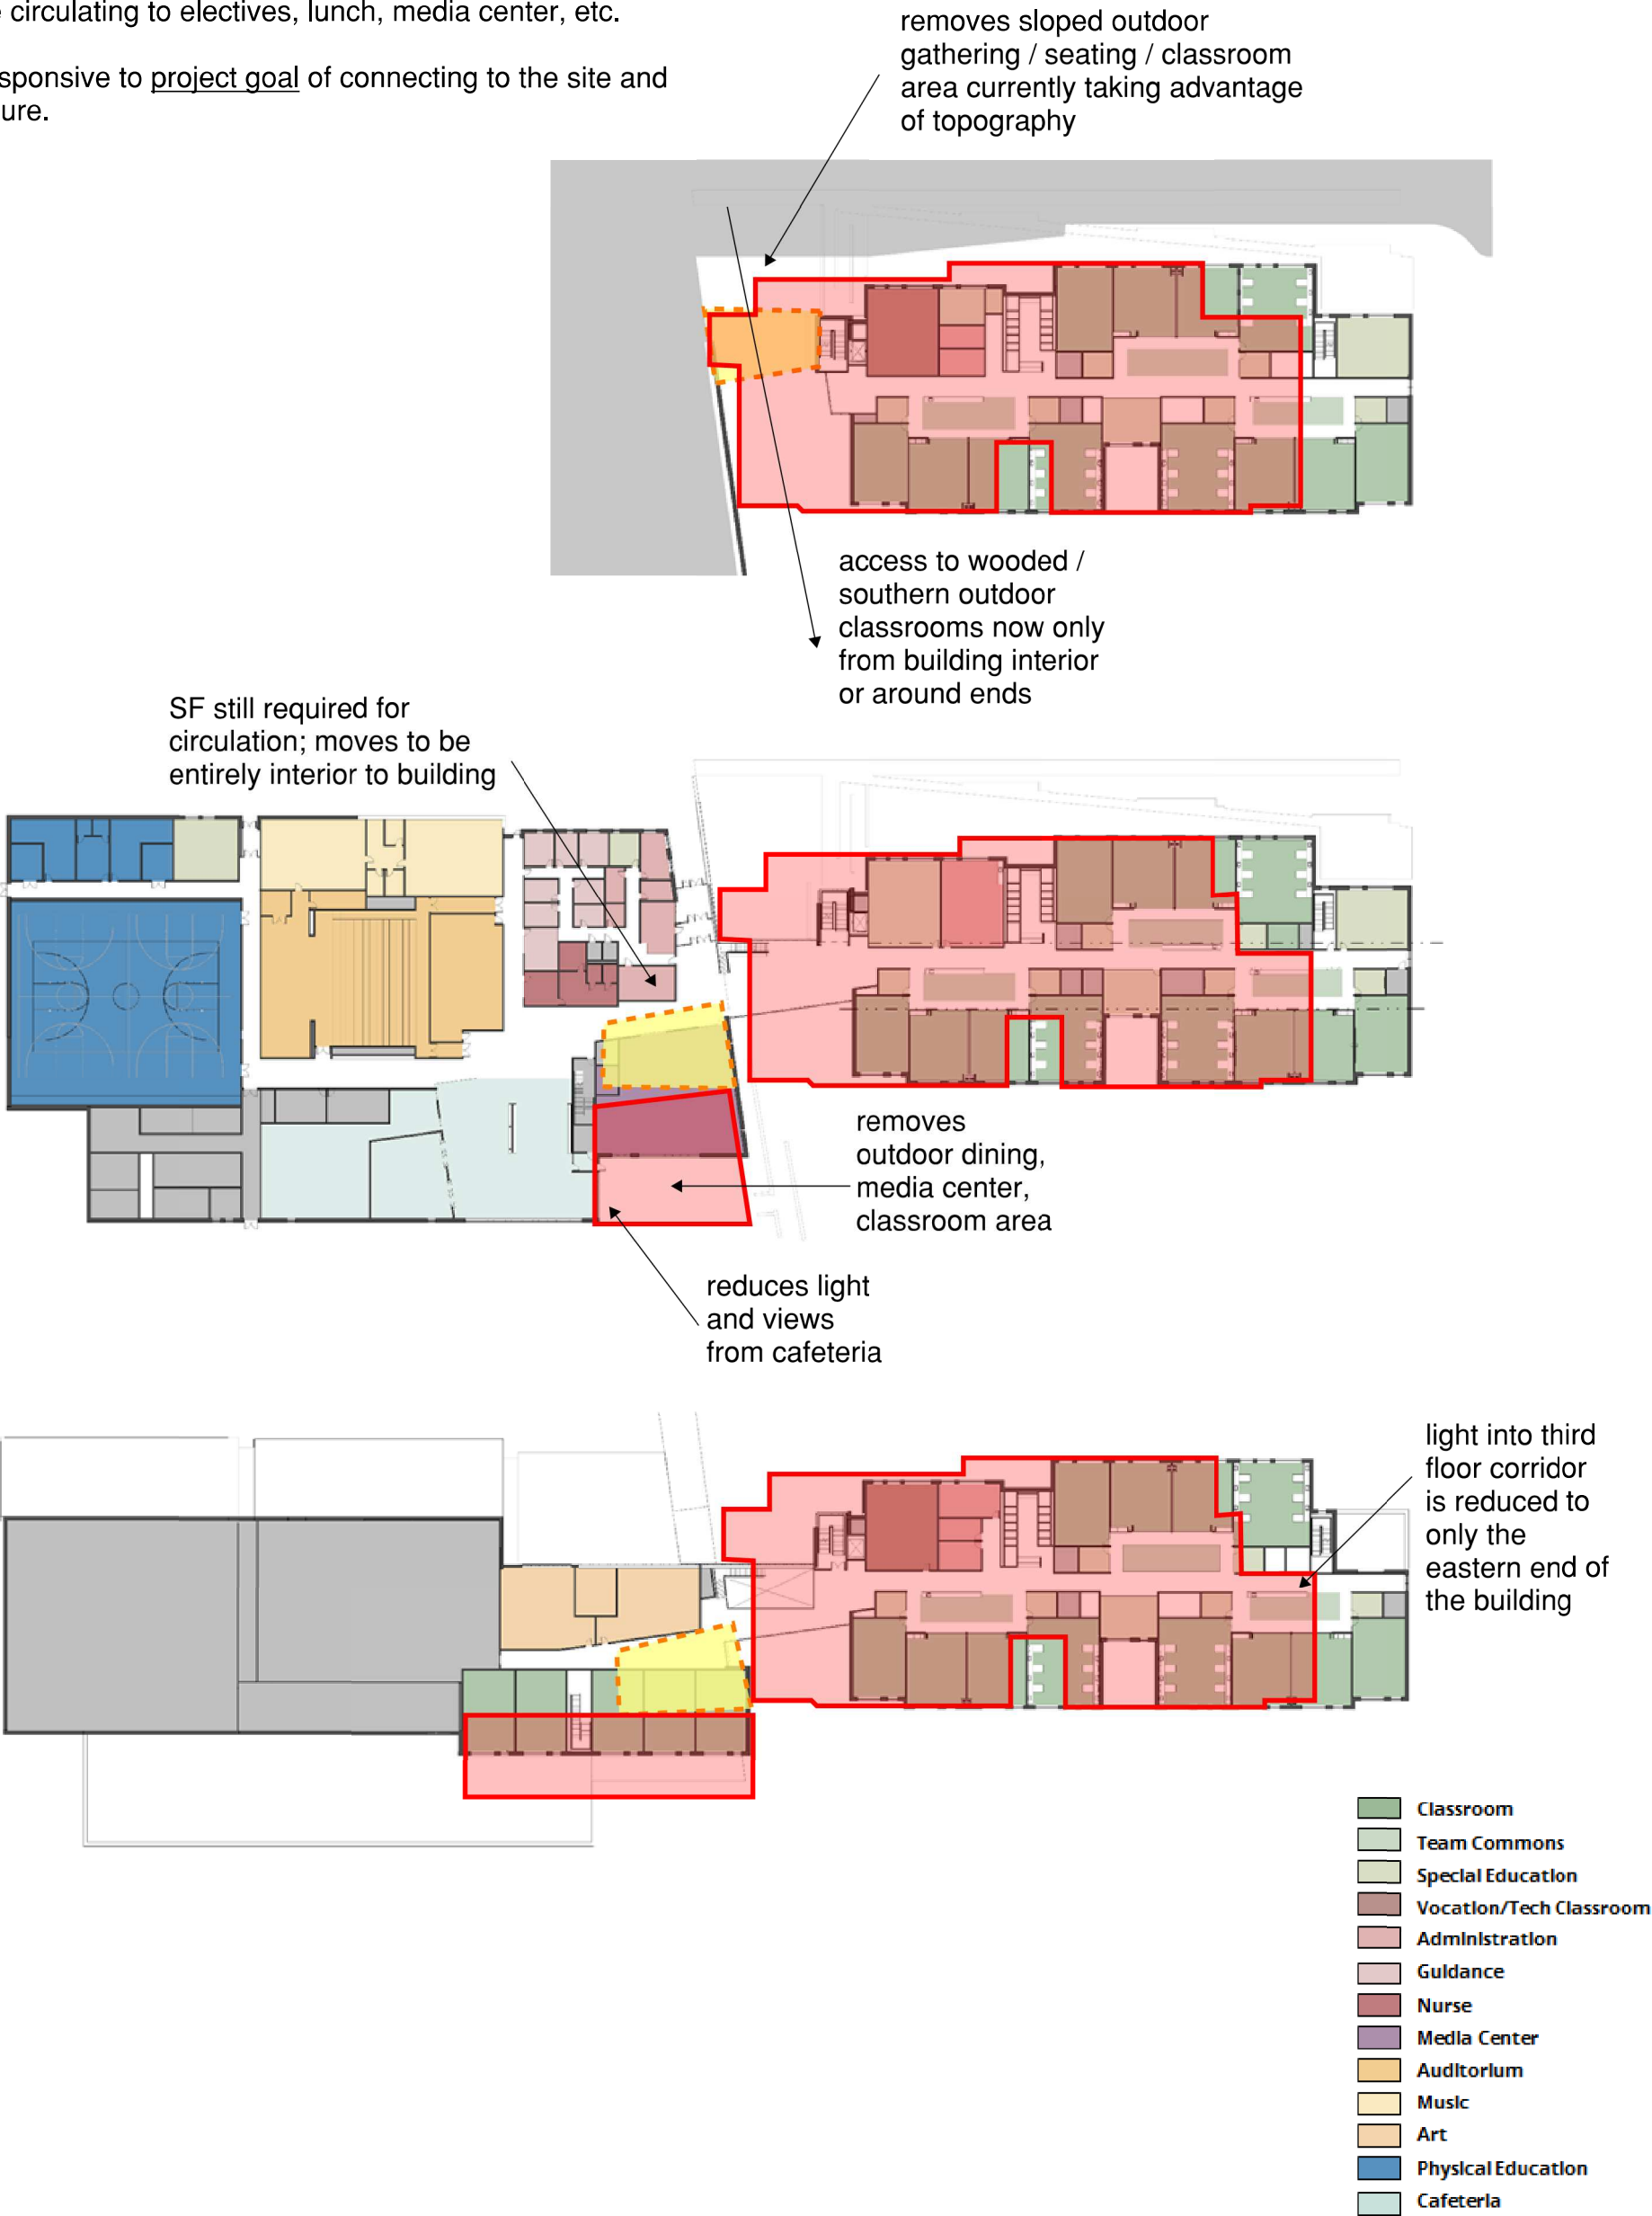
SE and SW corner classroom indents: Can these be eliminated? What is the functional purpose?

Reasons why the design team does not recommend this change:

Change to area of exterior envelope; rather, redistribution. Academic wing sized to minimize site manipulation; works with natural topography. Rooms and learning common are currently optimal proportion.

4. Arrangement of Spaces in Public Wing

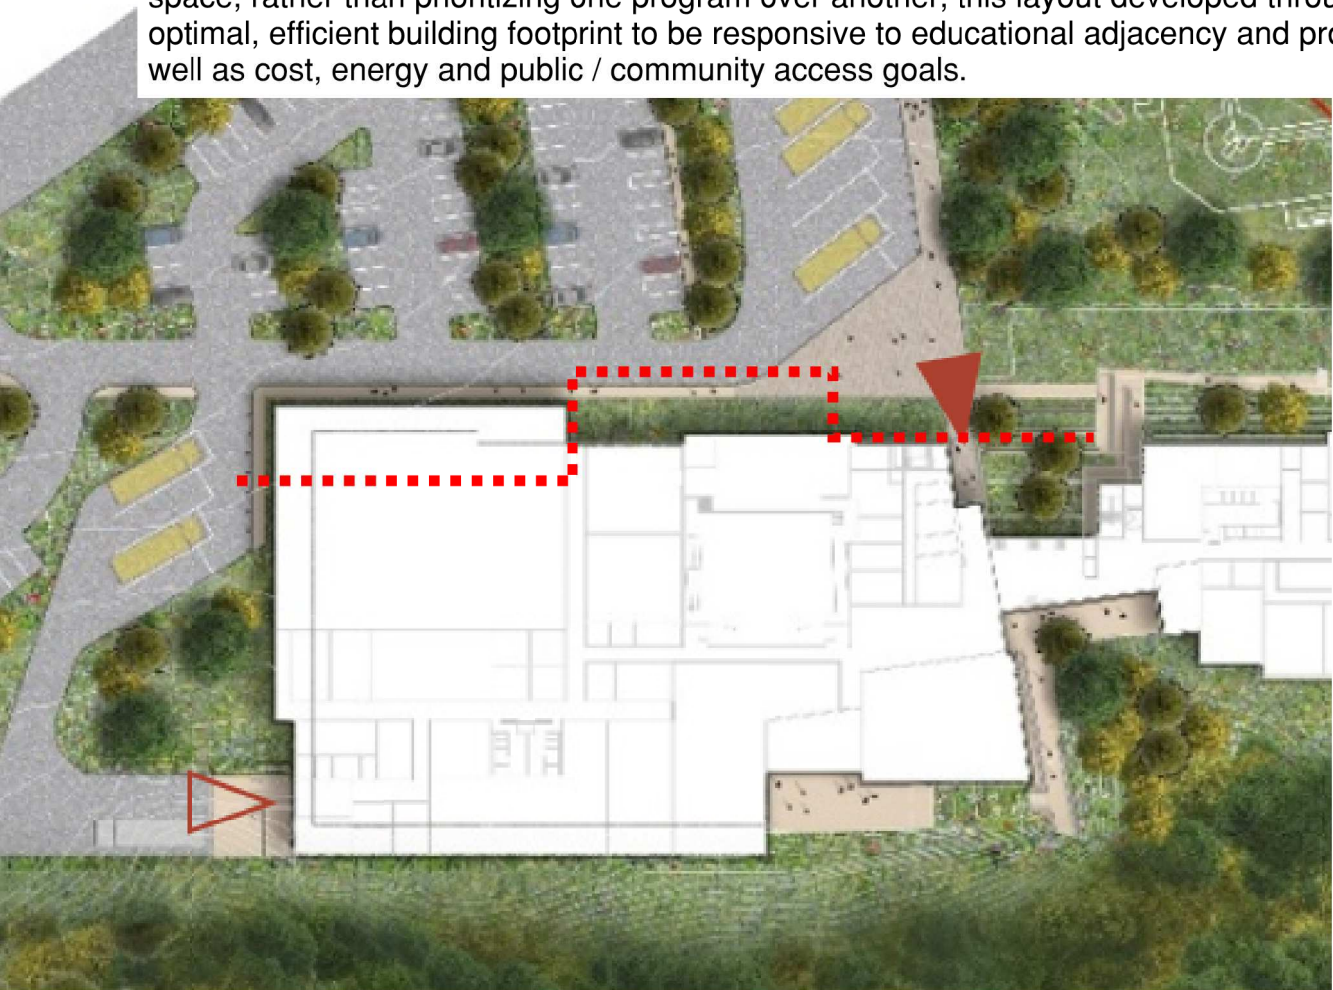
Can we swap Auditorium/music and gym? Relocates Gym closer to playing field

Currently the layout as designed (flow and access):

- Students rarely change clothes for gym/PE class. Therefore, many students will access the gym directly through the first door at the end of the corridor.
- If students are having PE in the athletic fields, they will know in advance and can go there directly from their last class.
- Much of gym use will be after hours by clubs and community. Current location makes it easy to separate from the rest of the school which is a benefit to custodial and security requirements.
- the cafeteria is currently more proximate to the auditorium which is a symbiotic adjacency and relationship for hosting events and performances.

Currently the layout as designed (site considerations):

- Due to the gym's deeper dimensional requirement, swapping the auditorium and gym would either (1) impact parking and site circulation negatively if allowed to push north, or (2) would require more fill to be brought in if the center of the building were pushed south with the cafeteria and kitchen moving farther downslope (also more tree removal).
- If the gym were rotated to not change the N-S thickness of the building, the auditorium and music rooms would become more remote; the bus and car parking on the west would be impacted and the mechanical / equipment / kitchen and cafeteria spaces would be stretched thinner becoming less ideally proportioned for utility of each space.

Either the Gym/PE or the Music/Performing Arts students are going to have a longer walk to the respective space, rather than prioritizing one program over another, this layout developed through an effort to create an optimal, efficient building footprint to be responsive to educational adjacency and program requirements as well as cost, energy and public / community access goals.
